STATE OF NORTH CAROLINA
DEPARTMENT OF TRANSPORTATION

October 7, 2005

Subject: **MINOR MODIFICATION for Individual Section 404 and 401 permits for TIP R-2616** for the proposed widening of US 601 from the South Carolina State Line to north of Marion Lee Road (SR 2105) south of Monroe in Union County; NCDOT Division 10. Federal Project No. STP-NHS-601(4), State Project No. 8.1690303, WBS Element 34485.1.1.

SITE 16 -L- STA. 315 + 75

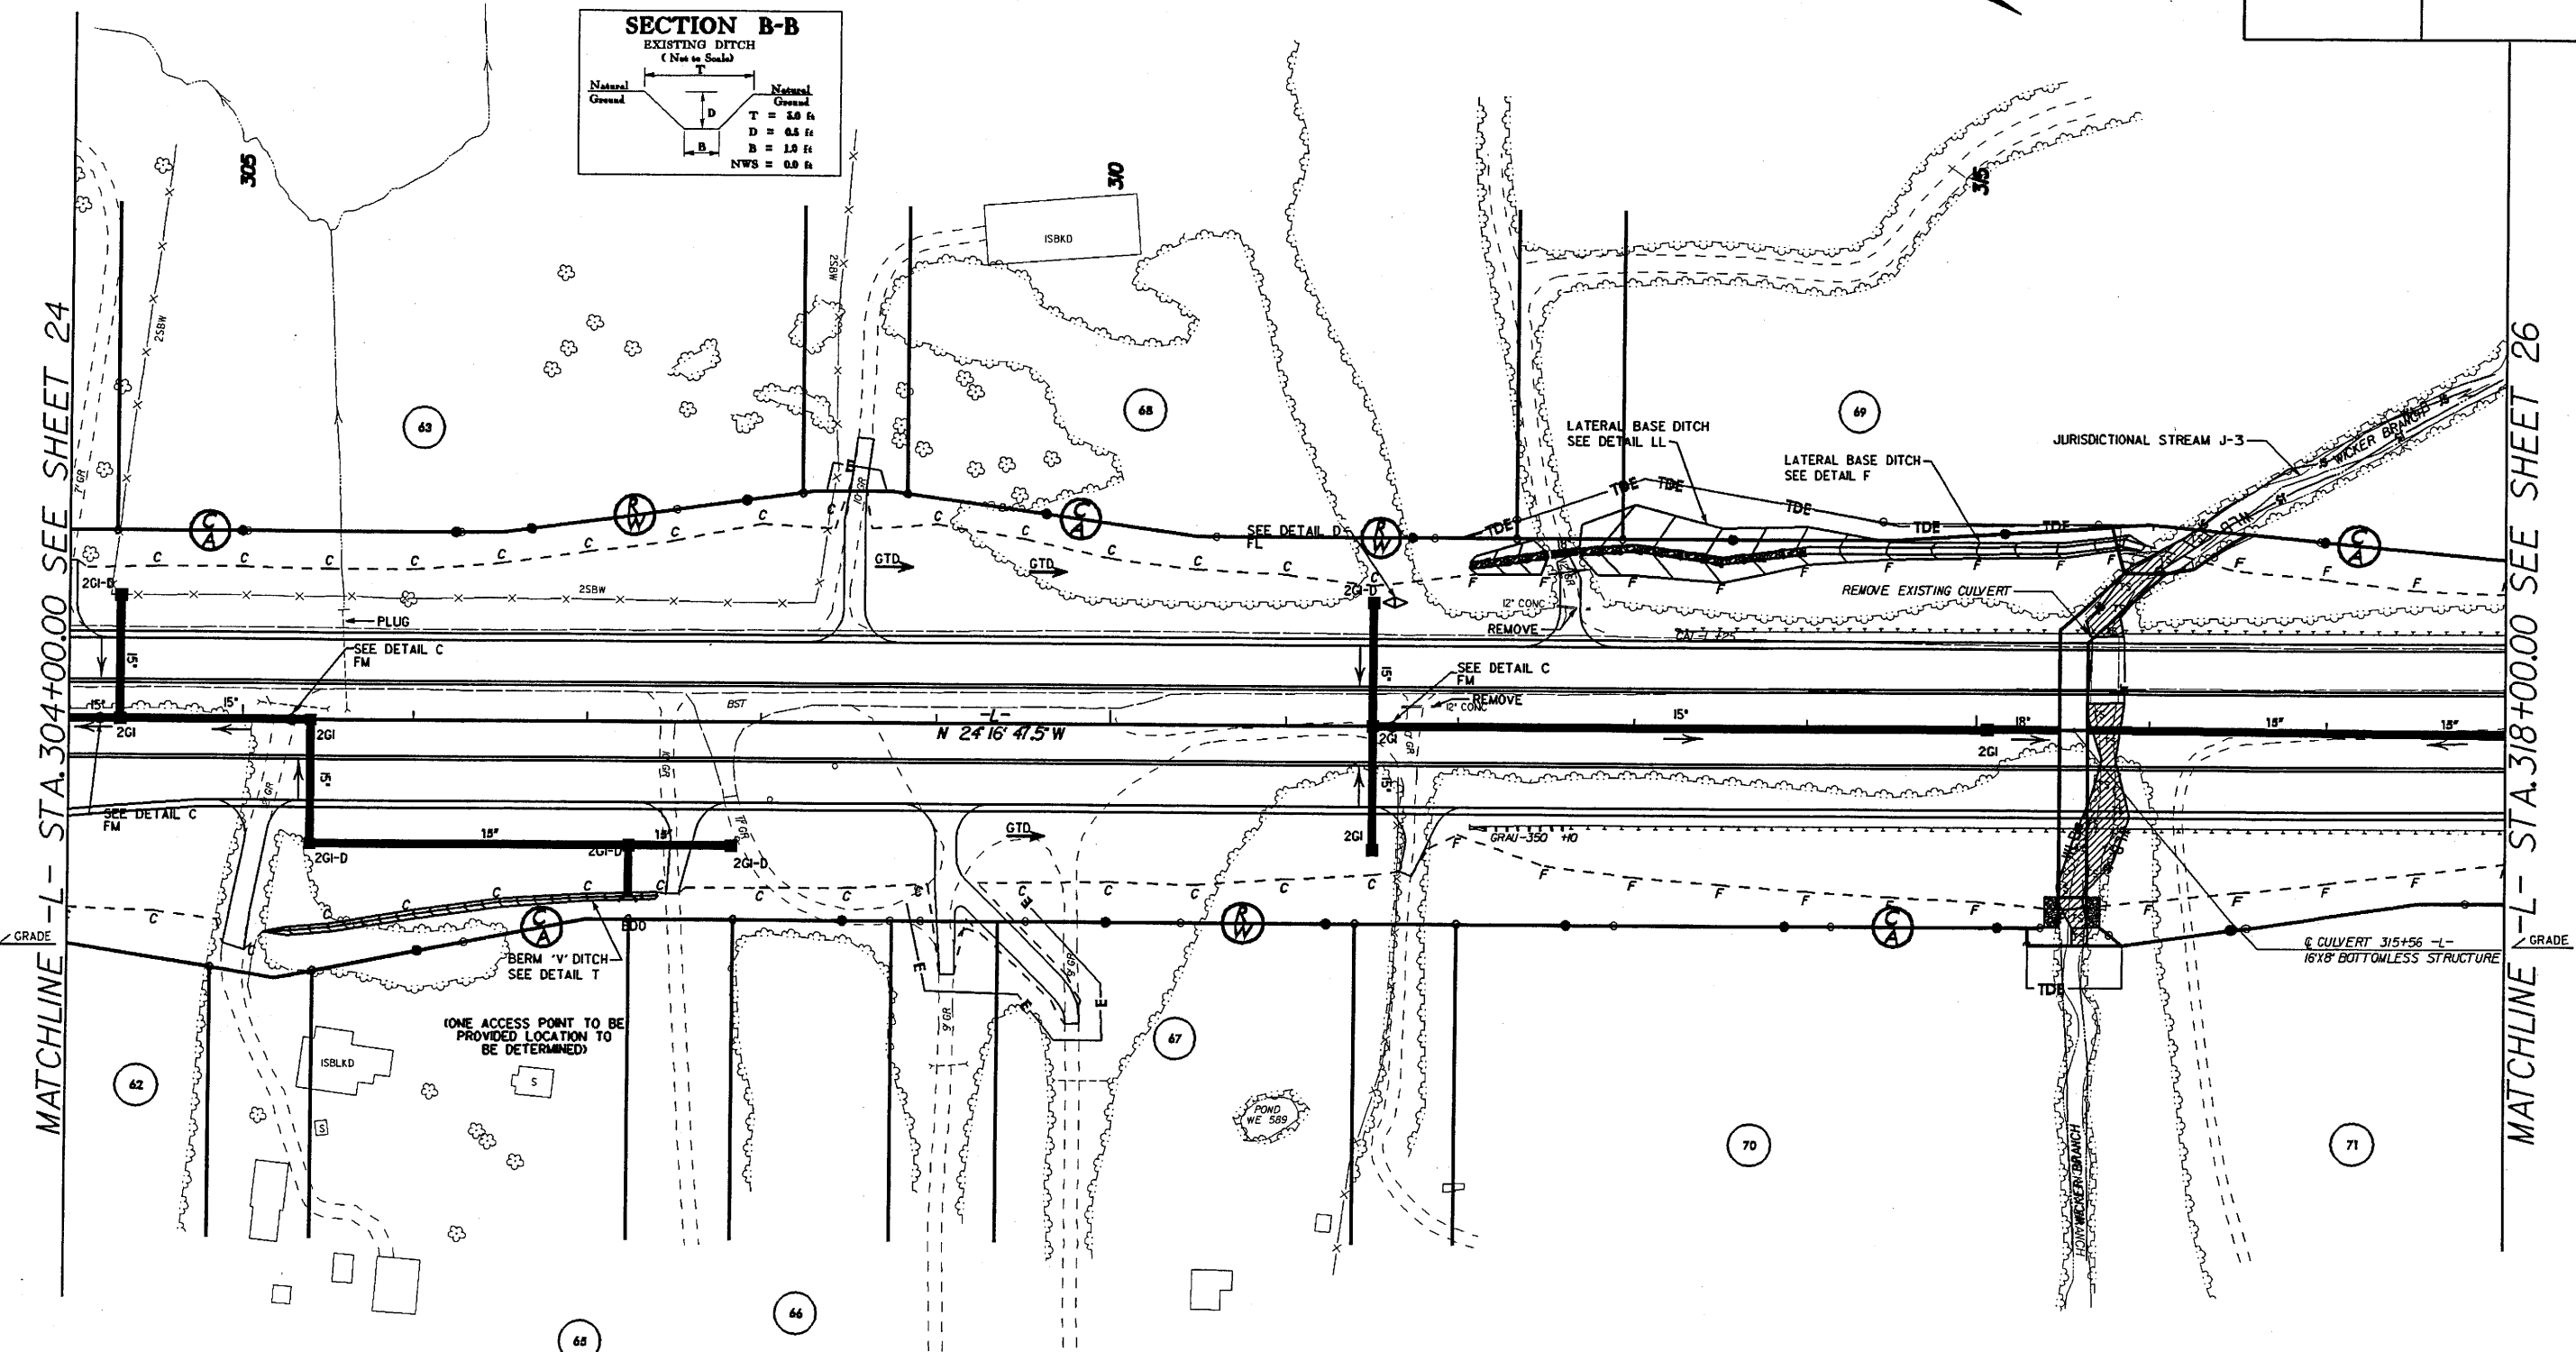
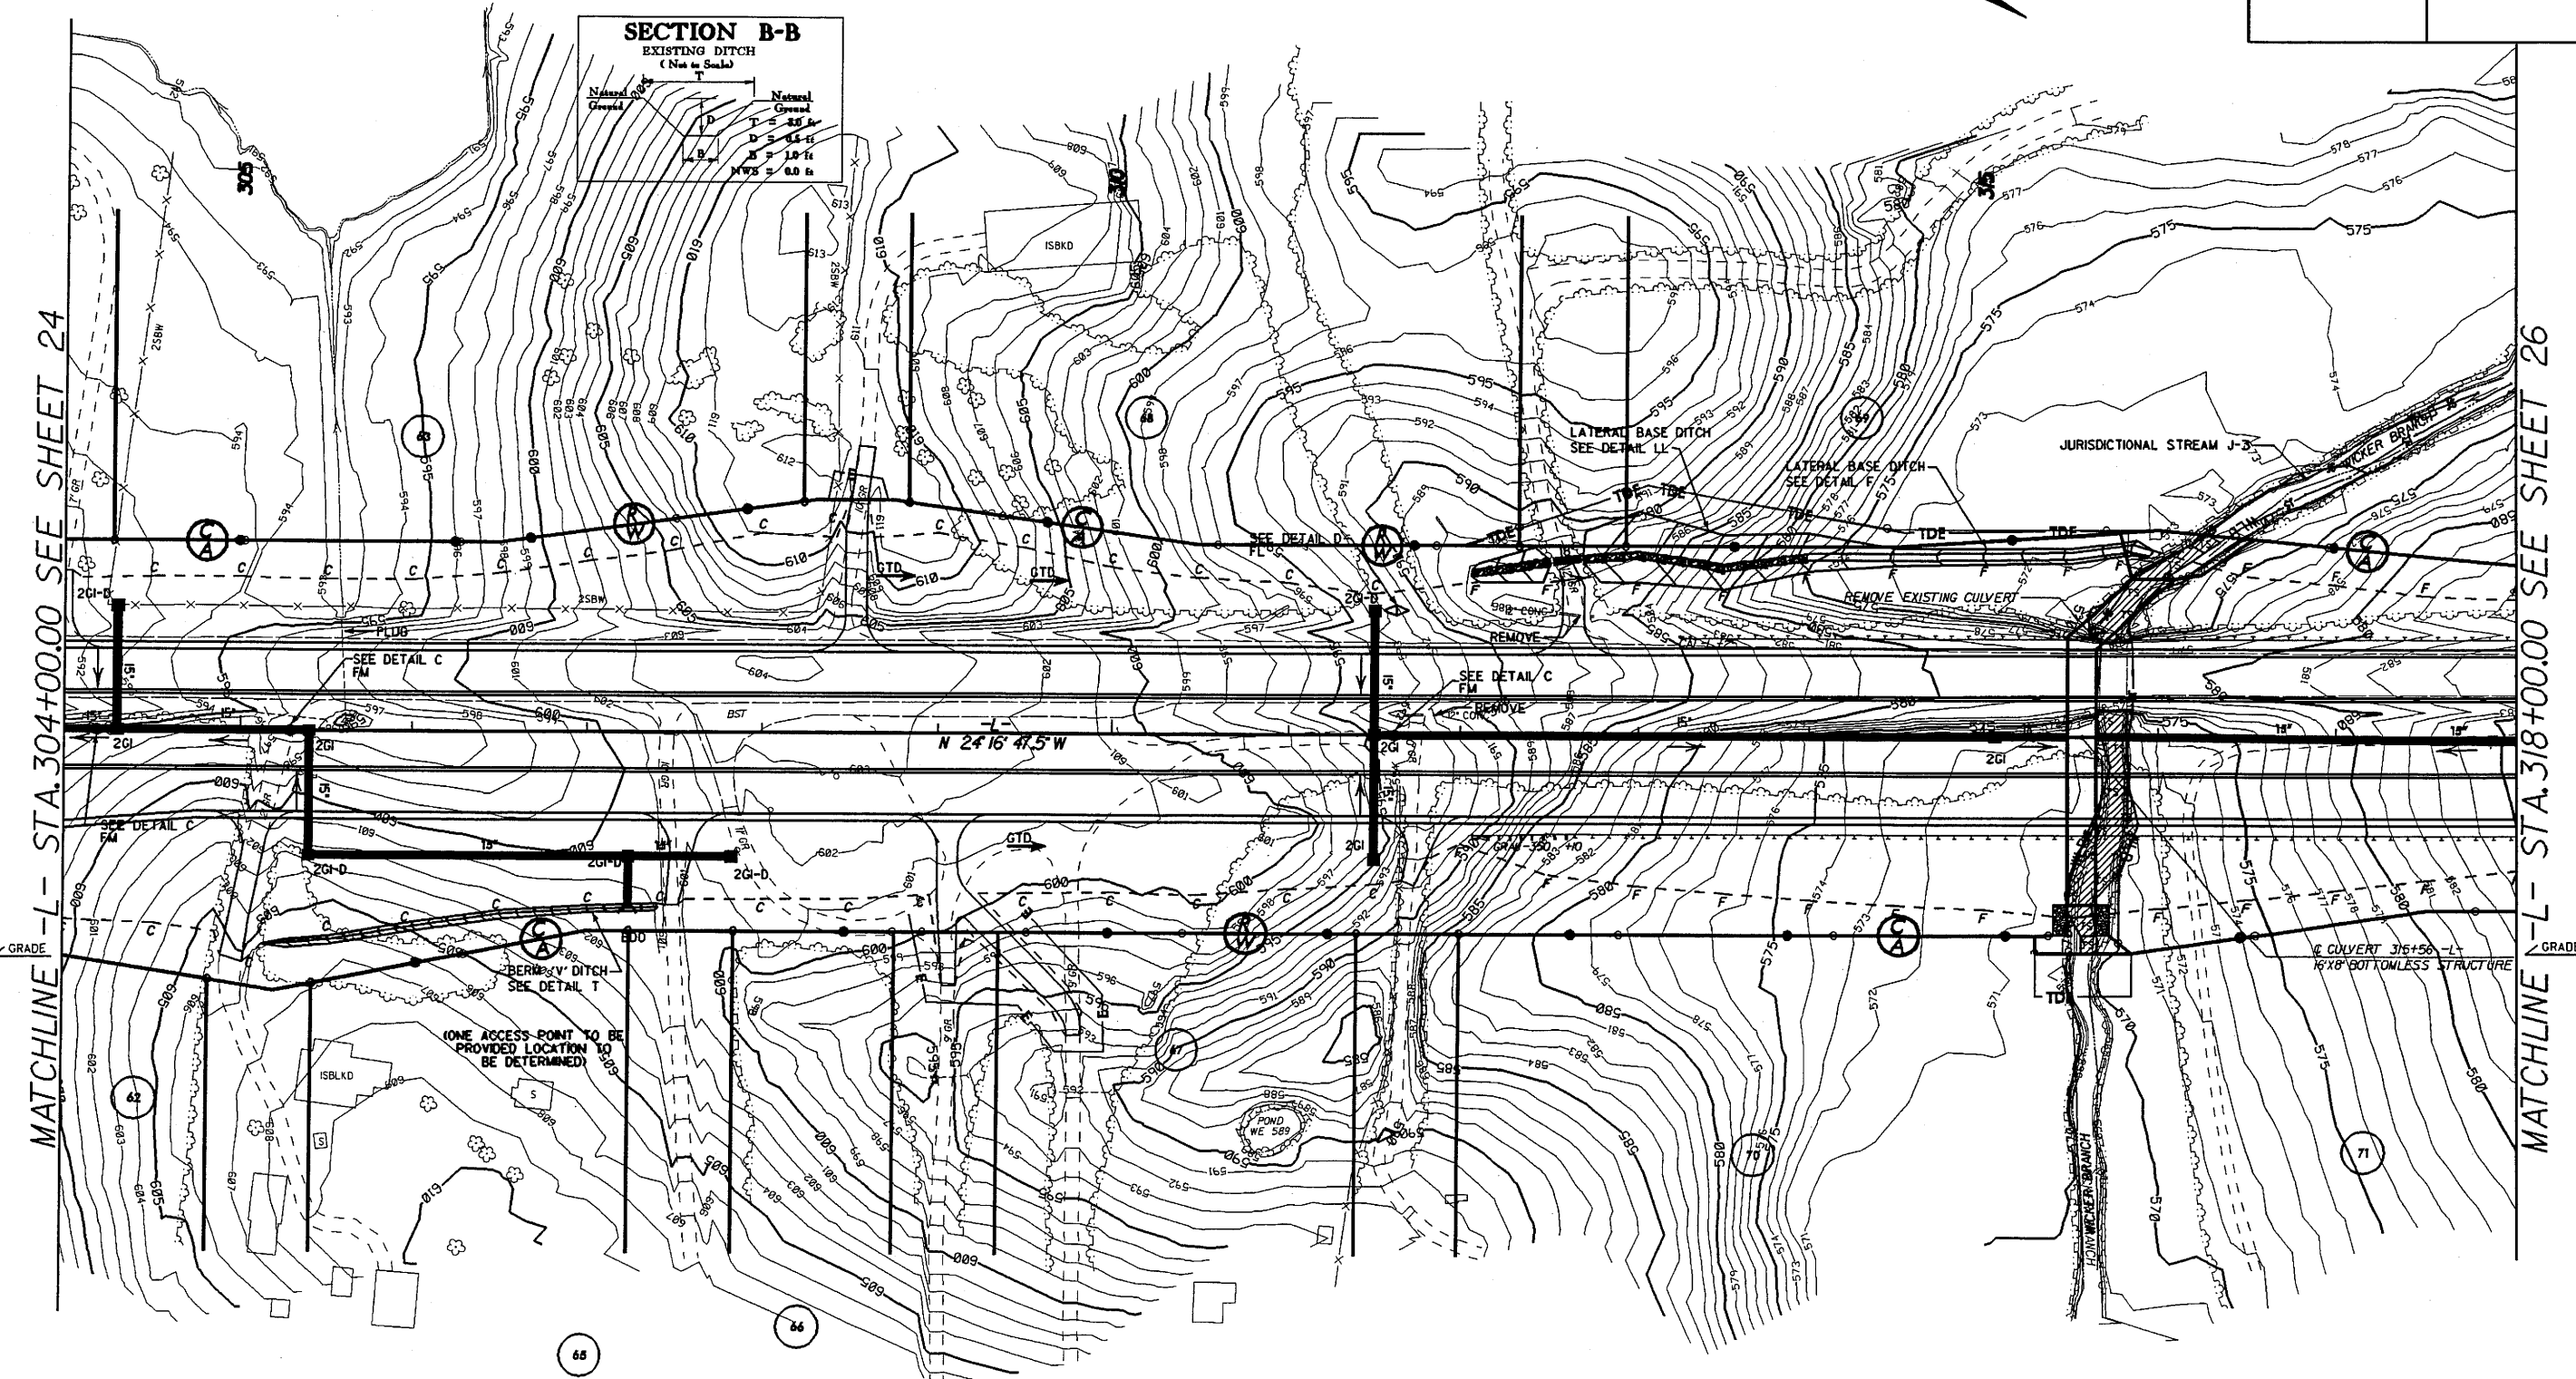
Please reference the July 21, 2005 Individual Permit application. During the Concurrence Point 2A and 3 meeting held on March 16, 2004, NCDOT made a commitment to investigate the feasibility of a bottomless culvert at the crossing of Wicker Branch, pending geotechnical studies and further design of the project. NCDOT has determined that it is feasible to replace the existing double barrel 8'x7' reinforced concrete box culvert with a single 16'x 8' bottomless structure. This revision will reduce the impacts at Site 16 from 210' to 25' of permanent stream impact. Permanent stream impacts are necessary due to the difference between the existing stream location and the new channel in the bottomless structure. The amount of temporary linear stream impact will increase from 20' to 210' to accommodate construction of the new structure.

These changes will reduce the total permanent linear stream impact for the project from 2,969 to 2,784, and increase the temporary stream impact from 464 to 654 feet.

SITE 15 -L- STA 315+75

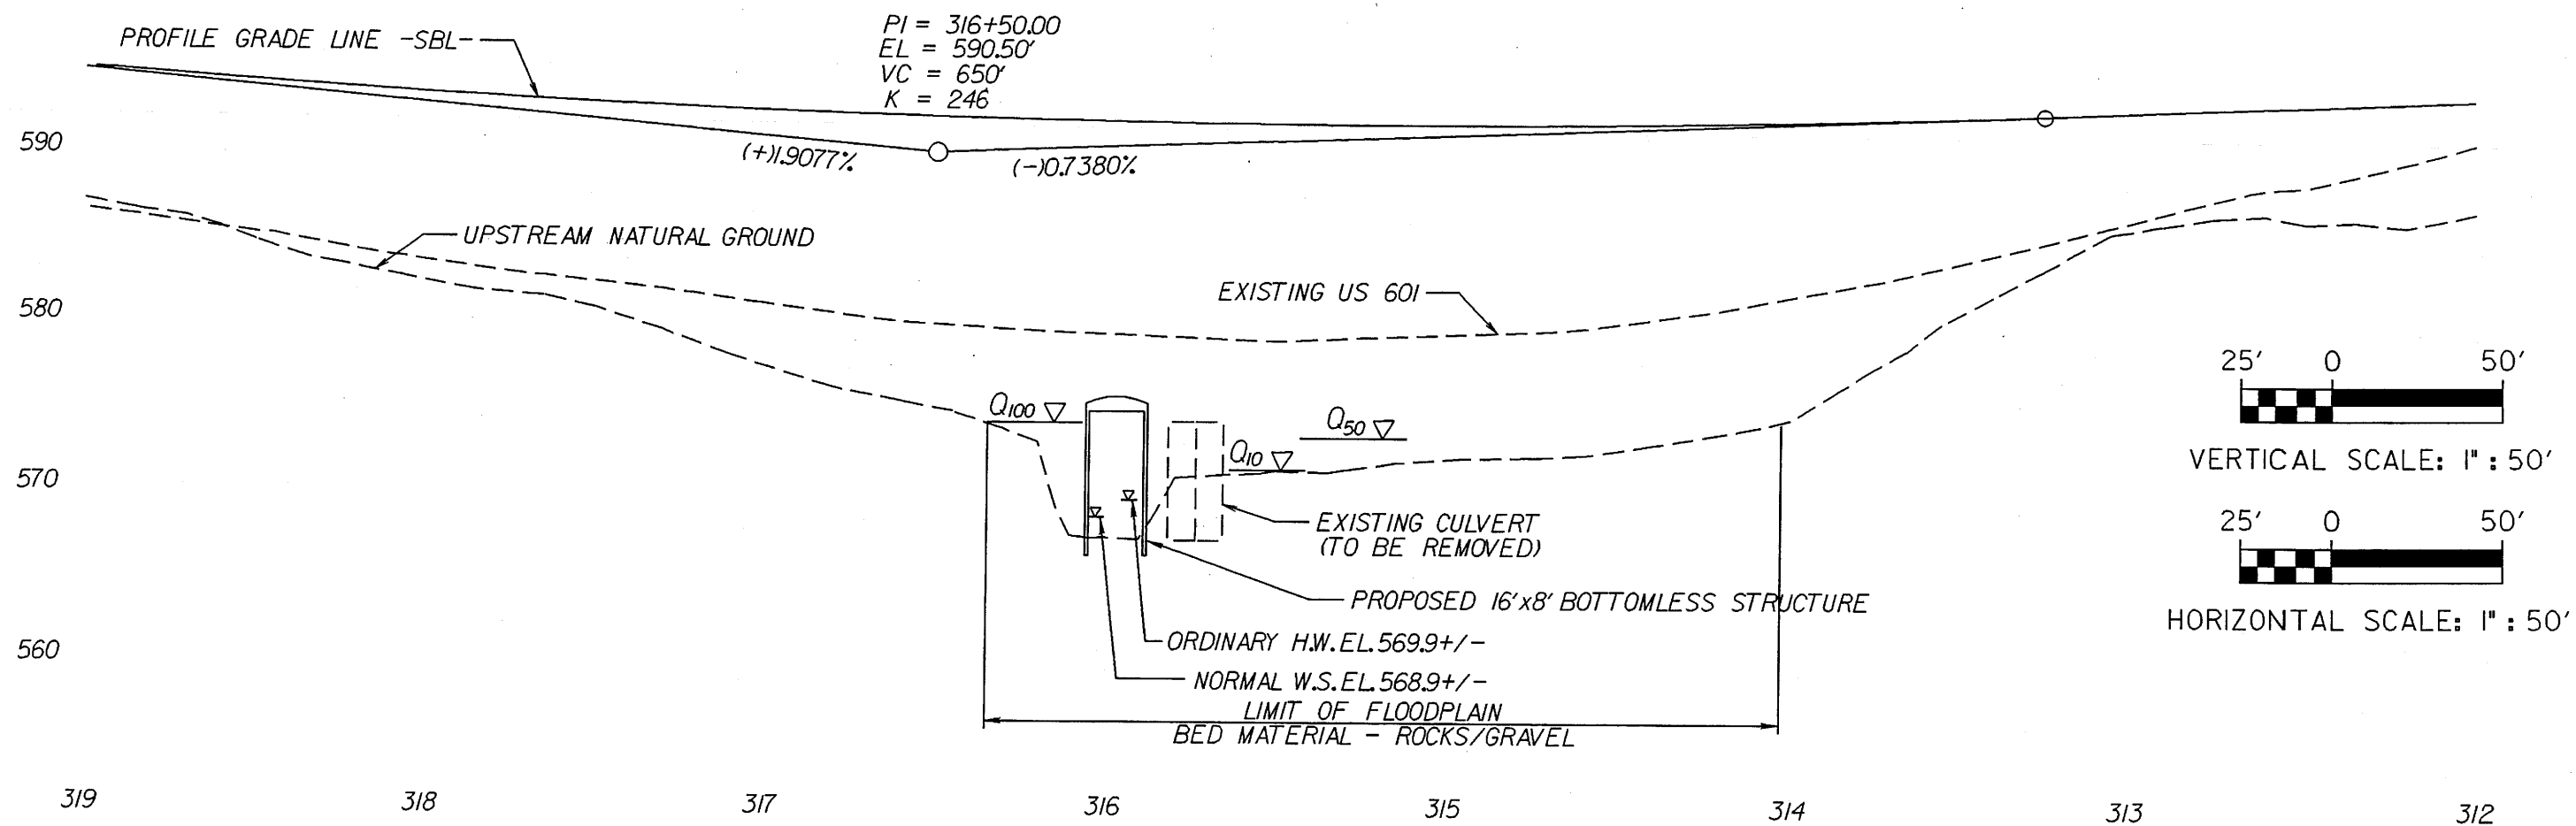
* Stream replacement by addition of bottomless culvert. Permanent impact of 25' due to difference between length of existing stream impact and proposed bottomless structure.
